PROPOSED CHANGES TO APPENDIX A, TECHNICAL SPECIFICATIONS, OF FACILITY OPERATING LICENSE NPF-37 and NPF-66

BYRON NUCLEAR POWER STATION

BRAIDWOOD NUCLEAR POWER STATION

EVALUATION OF SIGNIFICANT HAZARDS CONSIDERATIONS FOR PROPOSED CHANGES TO APPENDIX A, TECHNICAL SPECIFICATIONS, OF FACILITY OPERATING LICENSES NPF-37, NPF-66, NPF-72 AND NPF-77

FIGURE 1
EXISTING ISOLATION ARRANGEMENT

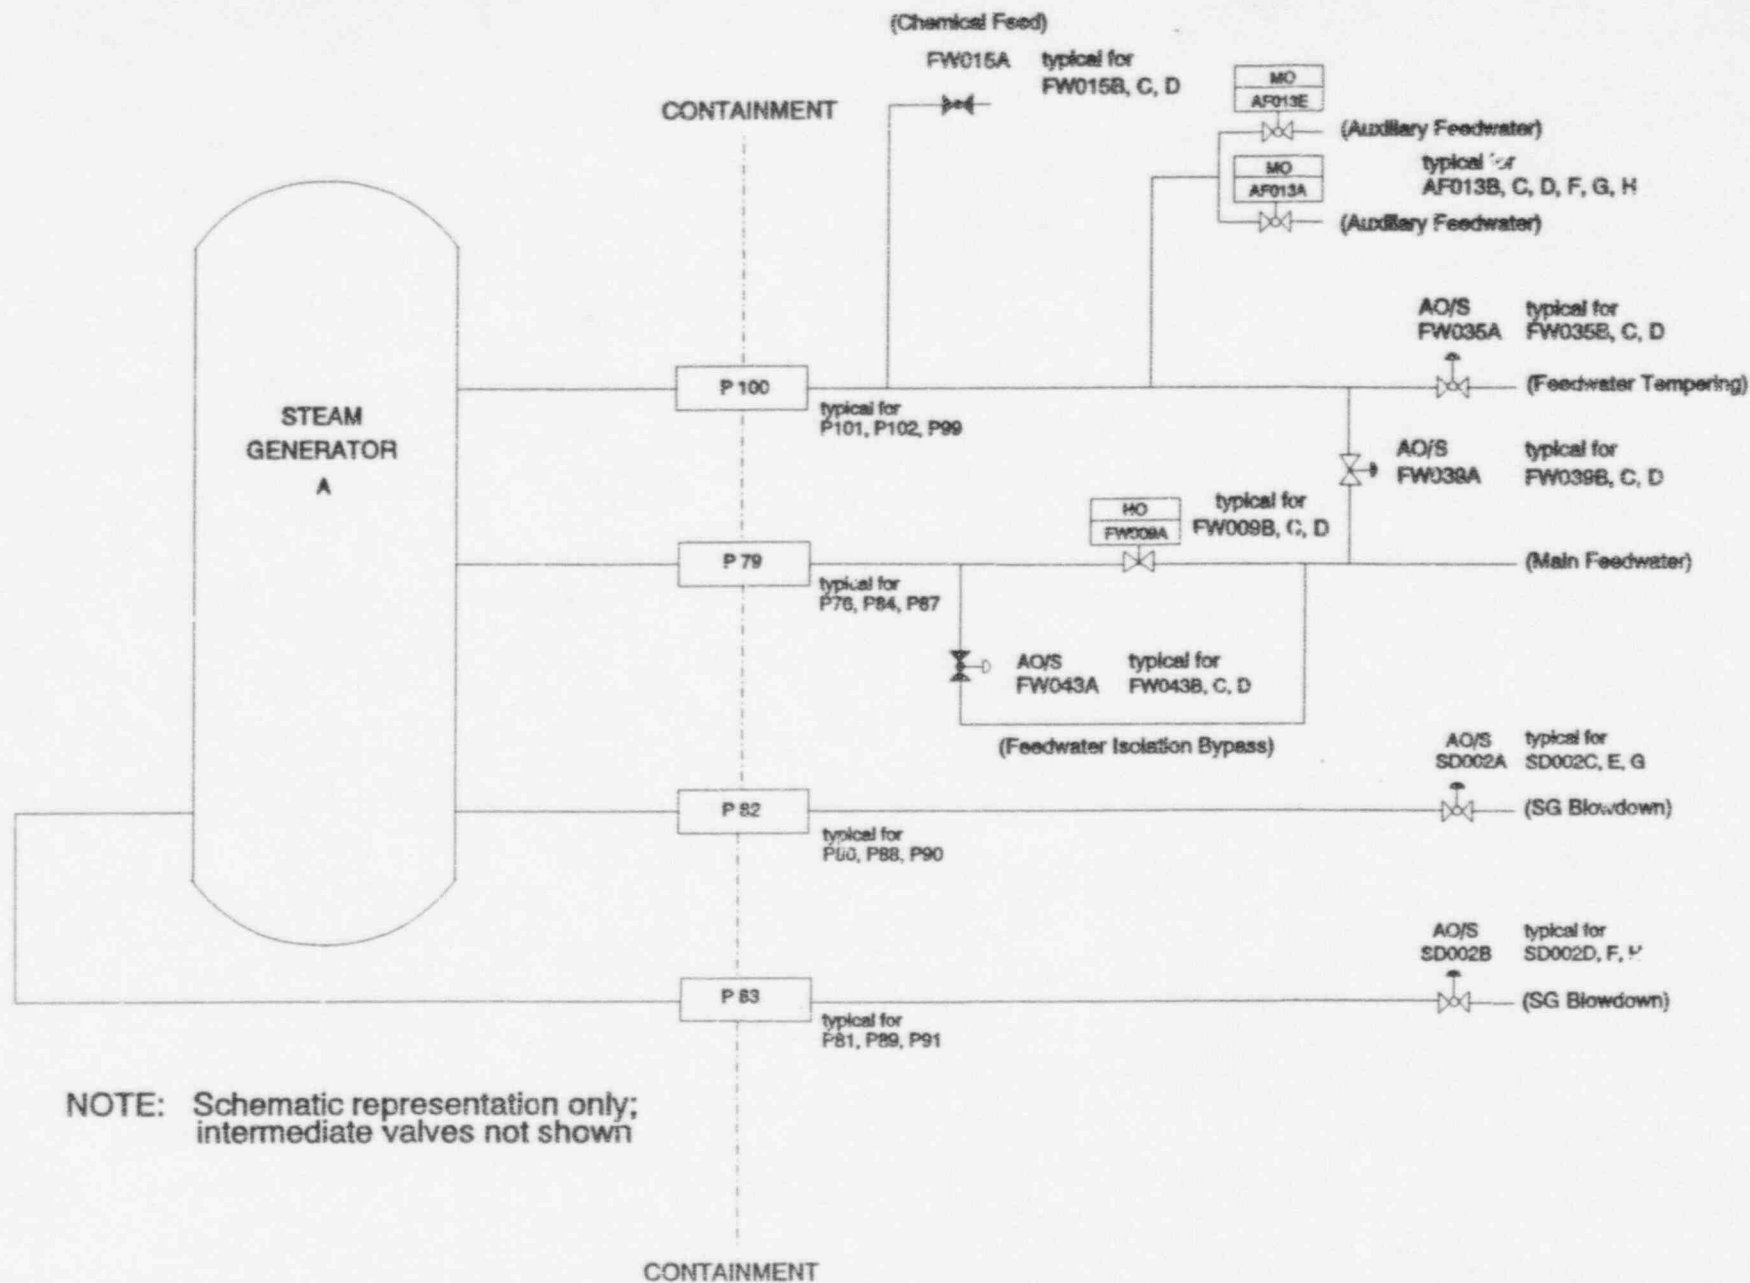
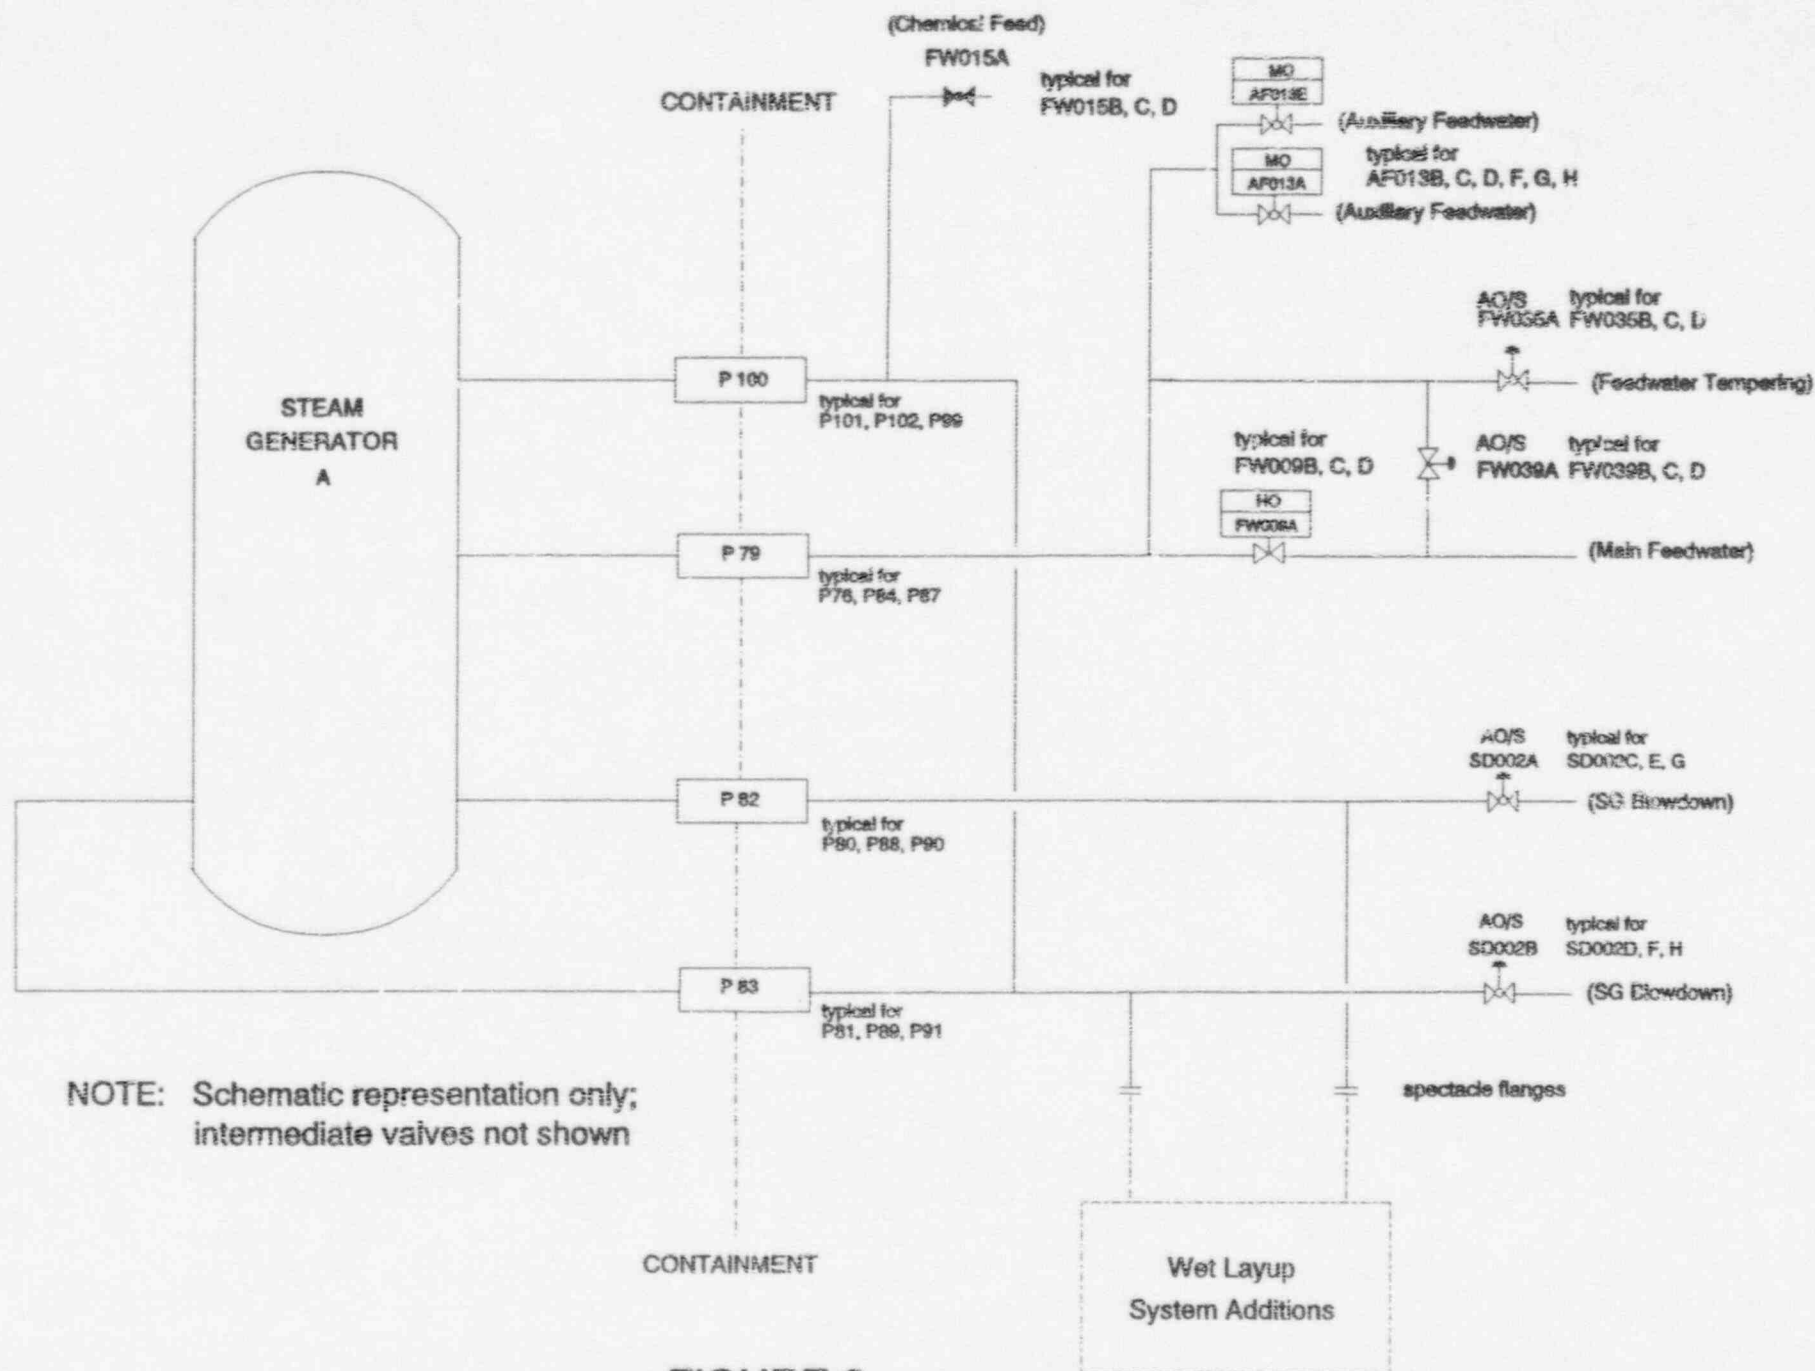
As a result of the planned replacement of the Westinghouse D4 steam generators at Byron Unit 1 and Braidwood Unit 1, changes will be made to the containment isolation piping arrangements at the penetrations associated with the Feedwater (FW) and Auxiliary Feedwater (AF) systems. As a result of these changes, there will be no split FW flow with the replacement steam generators. AF flow will be fed into the main FW piping outside of containment and the existing FW tempering penetration will be used for a new steam generator recirculation system to be used during periods of extended shutdown. Additionally, since the replacement steam generators use a feedring design rather than a preheater design, the FW Isolation Bypass line and associated containment isolation valves will no longer be required. Table 3.6-1 of the Technical Specifications (TS) must be updated to reflect these changes. These changes do not affect the containment isolation capability originally designed to the criteria in 10 CFR 50, Appendix A, General Design Criteria (GDC) 54 through 57 as reflected in the Byron/Braidwood Updated Final Safety Analysis Report (UFSAR).

These proposed changes result in the elimination of the FW Isolation Bypass isolation valves. These isolation valves are not required with the replacement steam generator design. The remaining isolation valves have not been altered in any way, only the piping associated with them has been altered to the revised configuration. These changes do not result in alteration of any containment penetrations.

FIGURE 2
REVISED ISOLATION ARRANGEMENT
(UNIT'S 1 ONLY)
